WURLITZER SERVICE SLANT

Wurlitzer Model C-110 Cassette

Insufficient engagement of some Cassette Tapes on Tape Deck Turntable causing cancellation when Cassette Tape is placed in "Play" position.

Figure 1

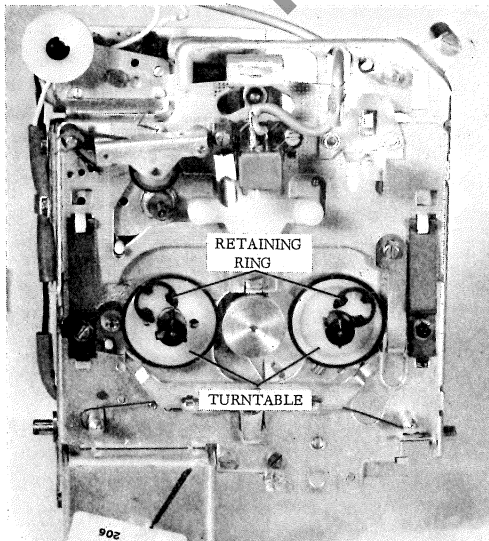
Installation of a Retaining Ring (used as a spacer) to provide additional pressure on the Turntable Springs.

1. Position one RETAINING RING, Part No. 0019030006, on each TURNTABLE as shown in Figure 1.
2. Lift SPRING sufficiently to provide clearance between TURNTABLE and SPRING, then install RETAINING RING on TURNTABLE SHAFT as shown in Figure 2.
3. Repeat Steps 1 and 2 for opposite Tape Deck.
